Avon Advisory Planning Commission Meeting  
**January 26, 2026 at 6:30 pm**  
at Avon Town Hall

## DPR 25-12: Park Place Crossing – 56-108 Park Place Boulevard (approx. address)

Planning & Building Department Staff Report

## Exhibit C – Planning TAC Letter (Page 1 of 4)

## Exhibit B2 – Revised Proposed Site Plan (Received 2-Jan-2026)

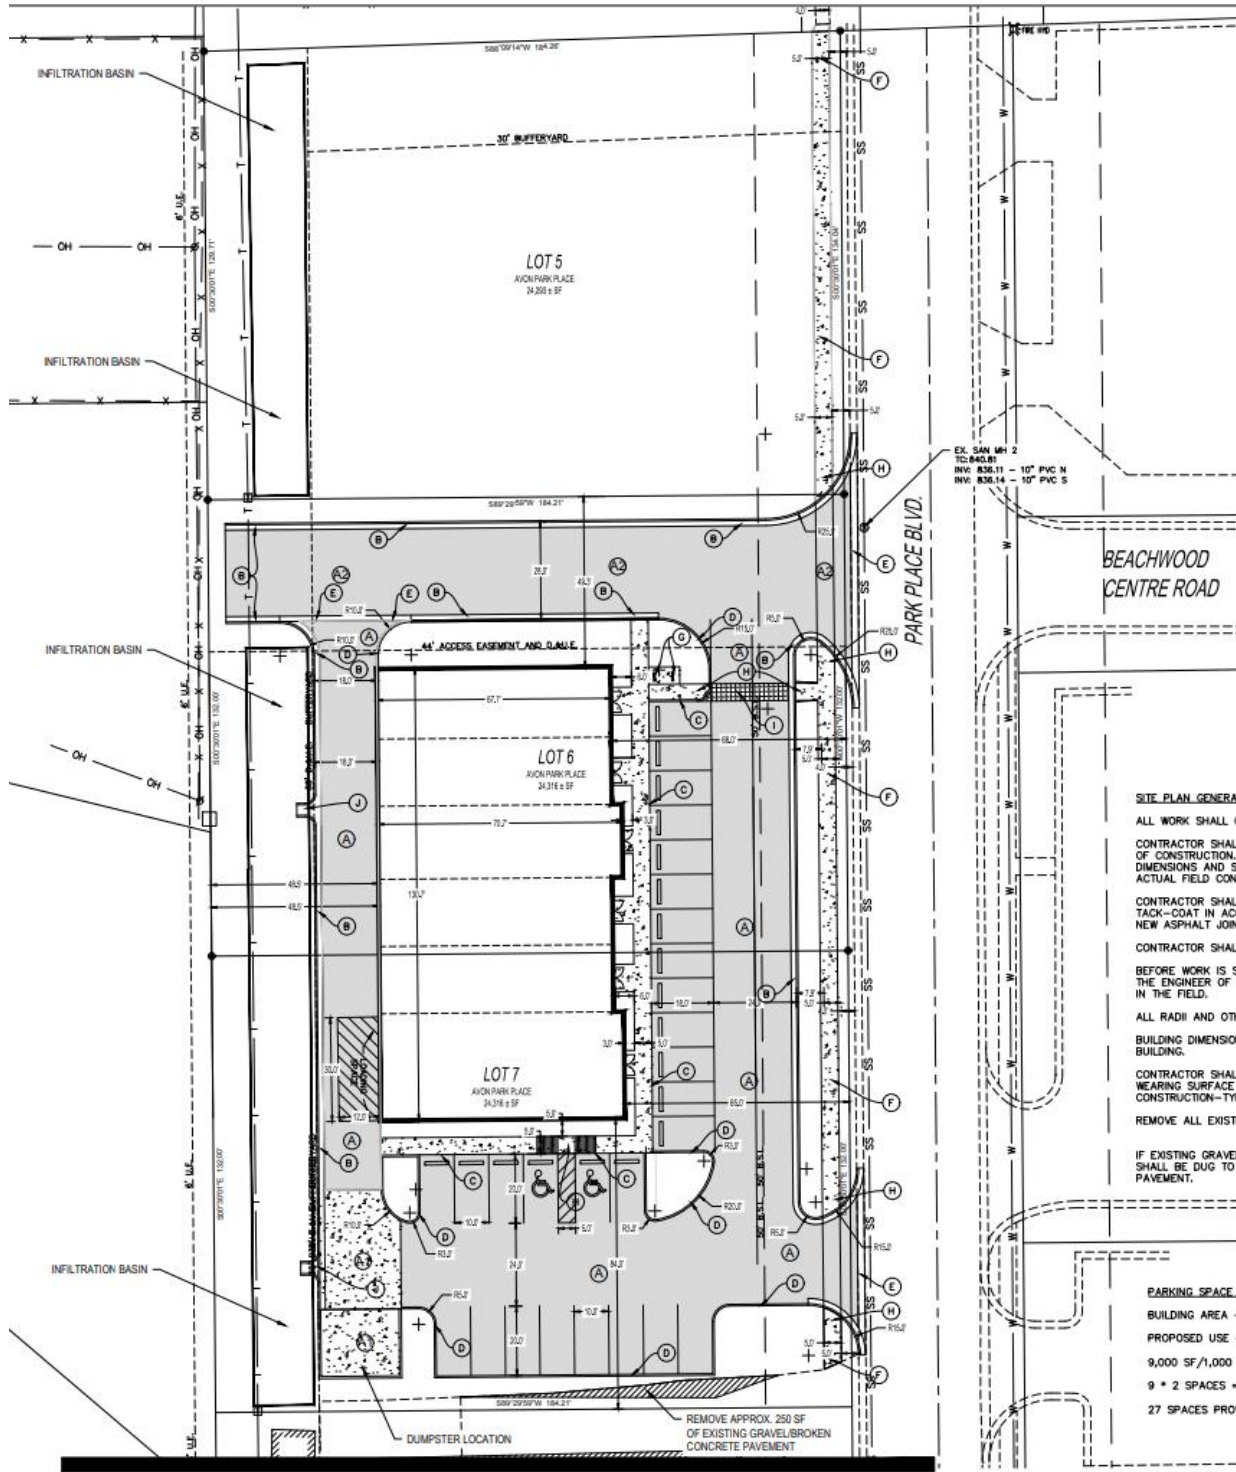
4. There appear to be discrepancies between the submitted site plan and building elevations in that the submitted building elevations appear to show six entrances on the east facade, but the site plan shows only four. Please make sure these plans match.

12. Per UDO Table 6.1, 90-degree angle parking requires 20-foot deep spaces, however, 18-foot deep spaces are shown in one of the rows. A variance or waiver can be requested, or the plans will need to be revised accordingly.

13. The application indicates that the building would be used for "office flex space". The closest match to this for purpose of parking requirements in UDO Table 6.3 would be "Office, All Others", which requires 2 spaces per 1,000 square feet of gross floor area, which would require 49 parking spaces for the proposed 24,293 square-foot building. Only 33 spaces are shown on the proposed plan. A variance or waiver can be requested or the plans will need to be revised accordingly, unless the proposed use of the building is revised.

15. Per UDO Table 6.4, a development providing parking spaces within a range of 26 to 50 must provide a minimum of two (2) accessible parking spaces meeting the standards of UDO 6.12(E). No such spaces appear to be indicated on the plans. Please revise the plans accordingly.

18. Per UDO 6.11(D)(3), the first twenty (20) feet of a drive must be kept free from parking maneuvers. The parking space at the southeast corner of the site would violate this requirement. Please revise plans accordingly.

19. Per UDO 6.5(A), a minimum five (5)-foot wide landscaped strip is required around the perimeter of all principal buildings exclusive of doorways and loading areas. The west façade and portions of the east façade do not appear to meet this requirement. Please revise plans accordingly.

# Exhibit B – Revised Site Plan (5-January-2026)

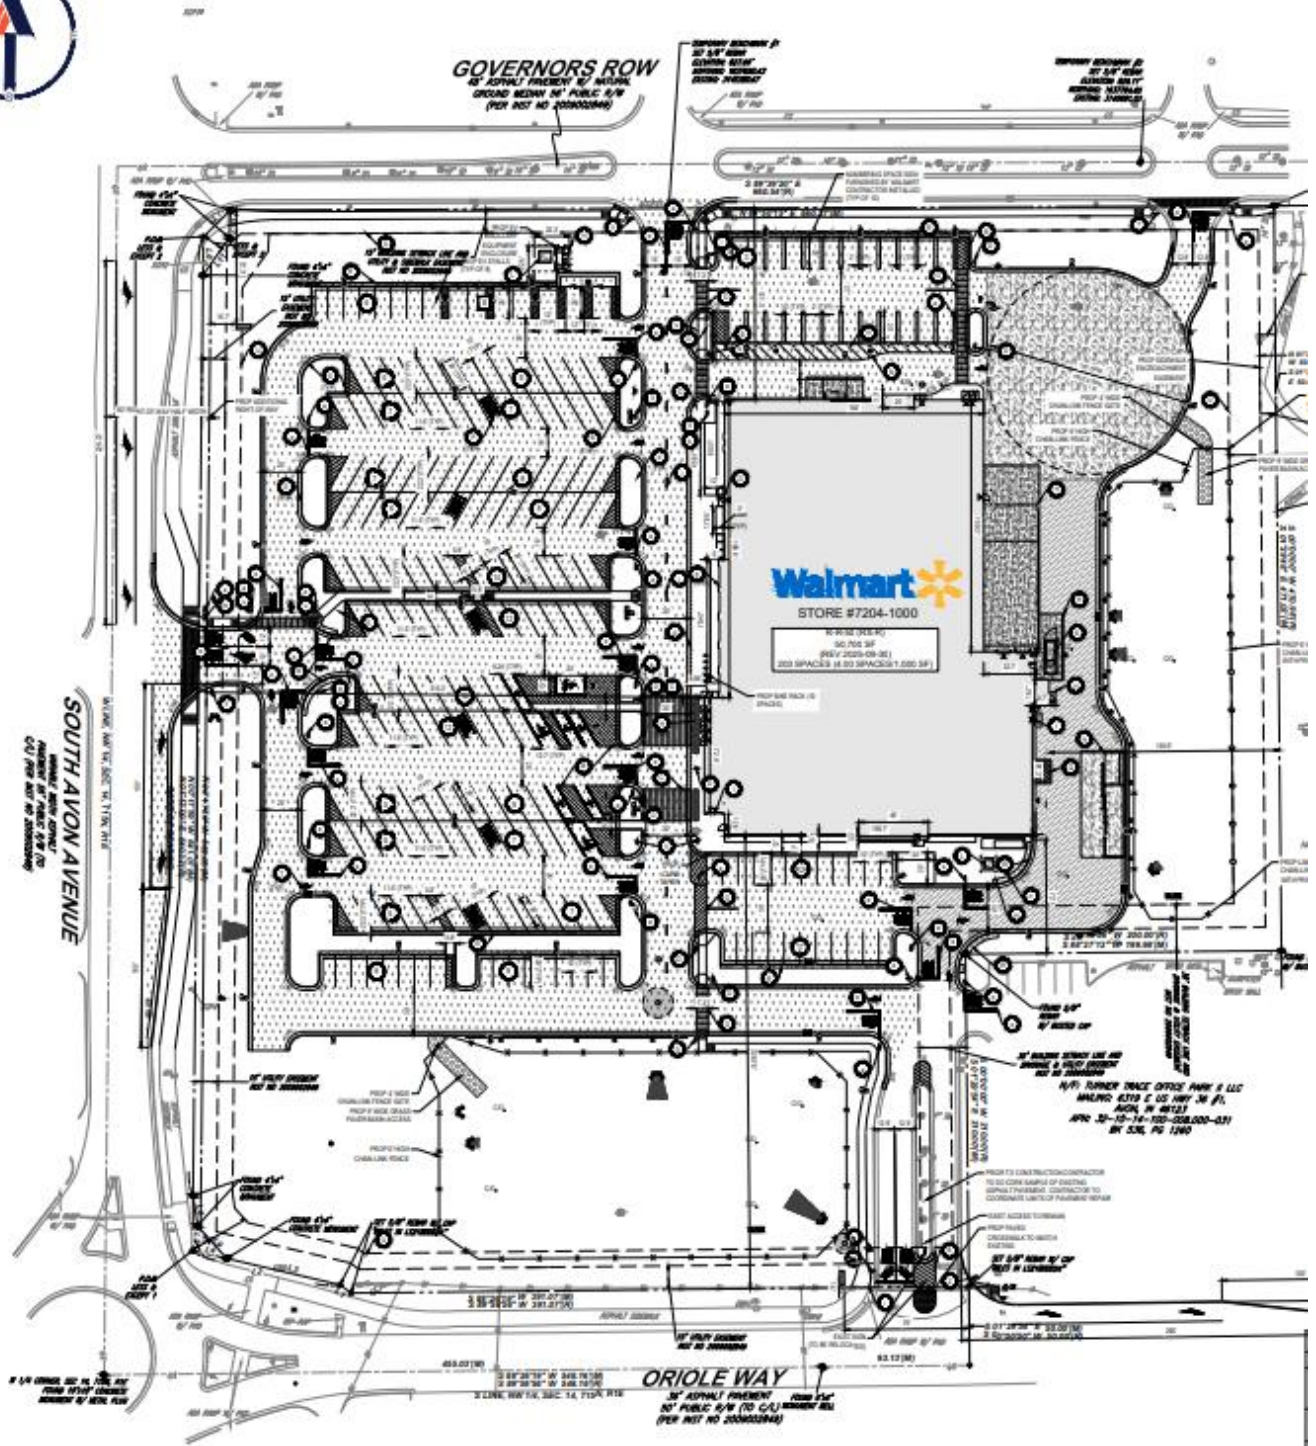
a) **Parking:** The site plan indicates the provision of 225 off-street vehicle parking spaces, with eight (8) of those being reserved accessible spaces. UDO Table 6.3 specifies that a minimum of 2.5 spaces per 1,000 square feet of gross floor area for a grocery store or other retail use, thus, a minimum of 127 spaces would be required for the proposed 50,700-square foot store. Based on the overall number of spaces provided, a minimum of seven (7) reserved accessible spaces would be required.

revised site plan shows bicycle racks in a compliant location, the plan only indicates five racks. At least one additional rack would be required.

## Exhibit D – Proposed Building Elevations

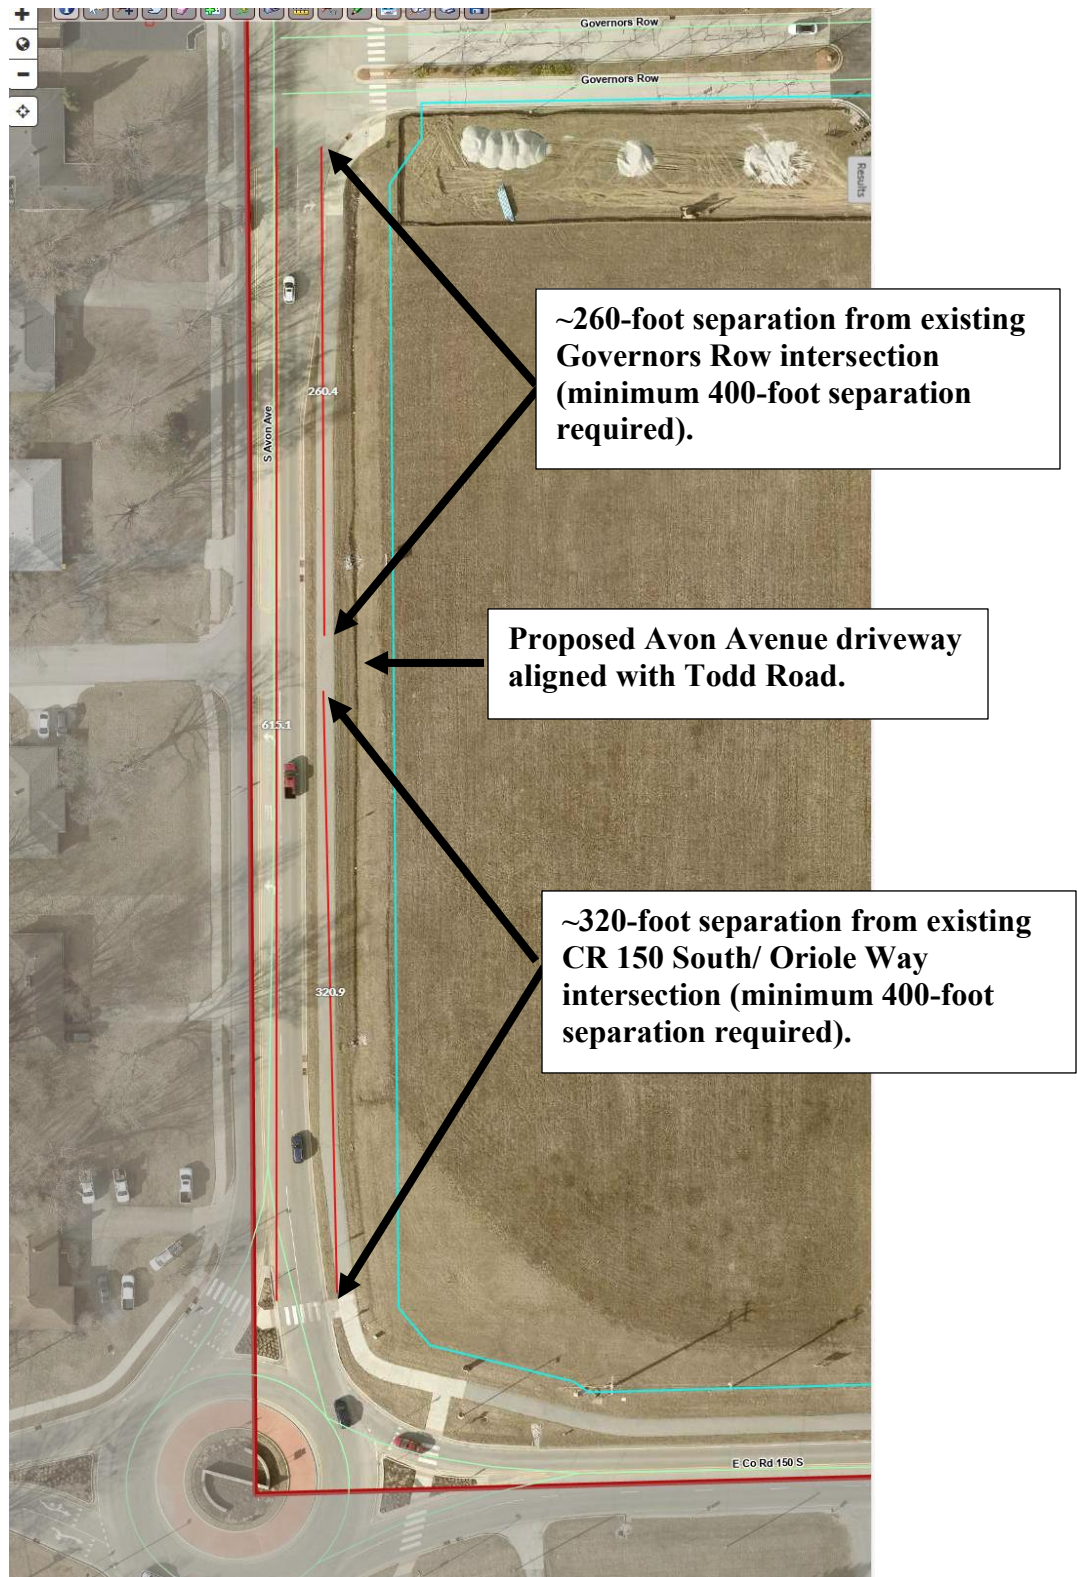
The revised building elevations, submitted subsequent to TAC review, appear to be deficient of several of the architectural standards (see Exhibit D).

UDO 7.10(D)(9) requires that the front of the building provide glazing on a minimum of 35% of the ground floor front façade. The elevations submitted do not provide dimensions and do not provide a calculation of the glazing provided. Staff's evaluation of the front façade has determined that 30% glazing would be provided. The petitioner would either need to provide revised plans or request a waiver.

UDO 7.10(E) requires that two of the five listed roof features be included. The revised plans indicate compliance with only one of these features.

The plans do not indicate compliance with UDO 7.10(H) which requires provision of two of the listed amenity options in order to contribute to the establishment and enhancement of community and public spaces. Plans should be revised accordingly.

3. Prior to issuance of a building permit, a revised set of plans shall be submitted, requiring approval by the Administrator, indicating compliance with all architectural requirements of UDO 7.10.

# Exhibit F – Lighting Plan

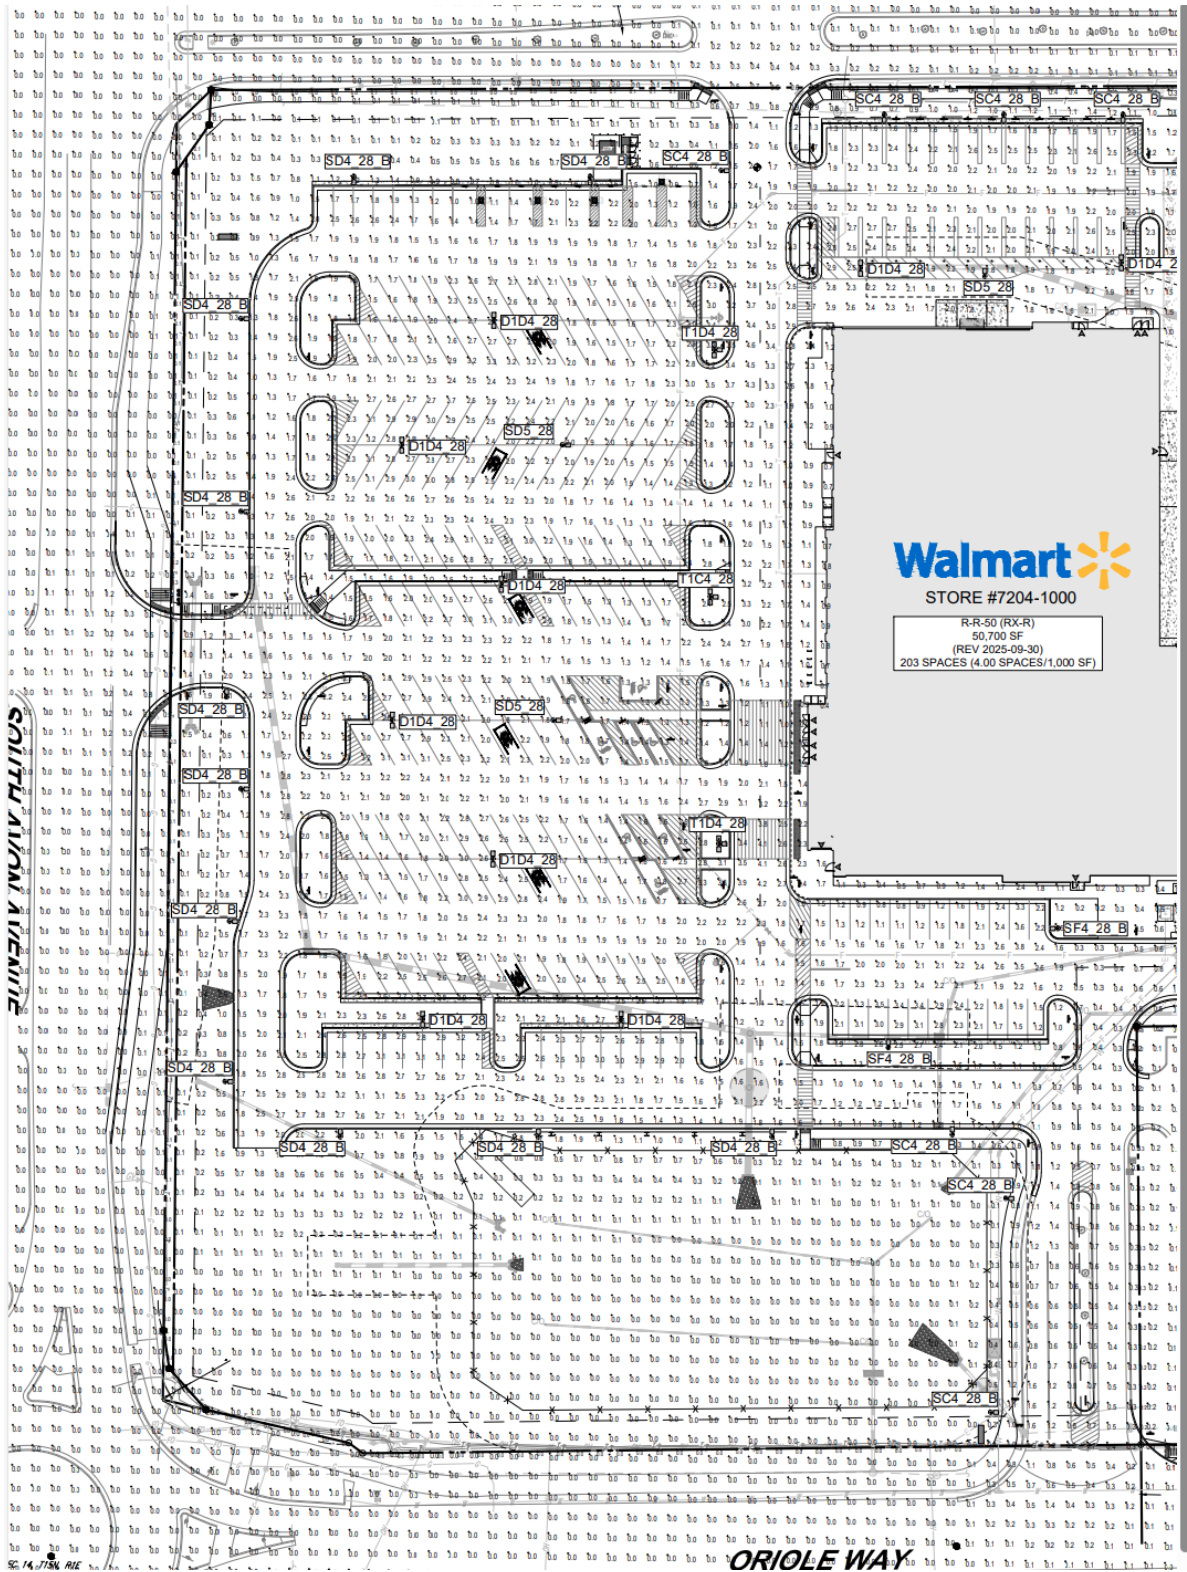
*Petitioner’s response: “the light levels exceed only in a small area along parking close to the right-of-way line, but falls off before the edge or cartway.”*

*Petitioner’s response: “trespass complies on adjacent residential and commercial properties. The only trespass is along a right-of-way, is only 0.1 Fc higher than max permitted, and falls off to compliant levels before the cartway of Governors Row.”*

**If the requested waivers are not approved**, staff recommends that additional conditions would be needed requiring revised plans meeting the lighting standards and to remove the proposed driveway access onto Avon Avenue.

## Exhibit D – Building Elevations Building A

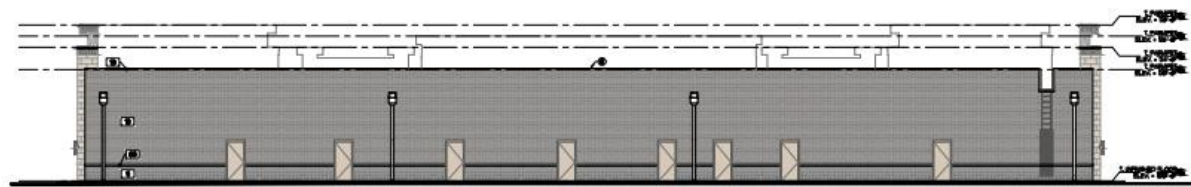
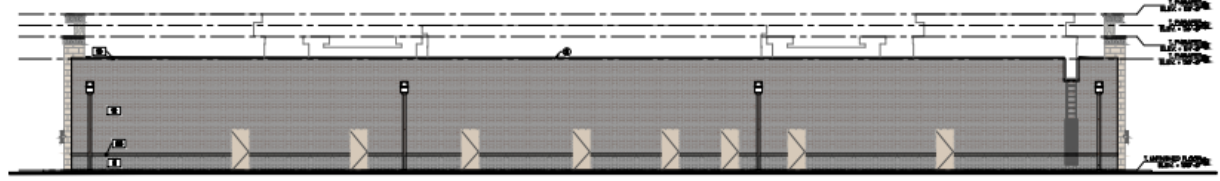
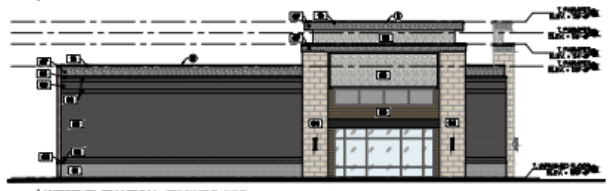
The proposed percentage of brick ranges from 36% on the front façade to 97% on the rear façade. Therefore, the overall appearance of the buildings will meet the intent of the UDO for having high-quality materials. While the front façade does not meet the 80% requirement, the change of materials offers a superior visual interest to warrant a deviation from the brick standard.
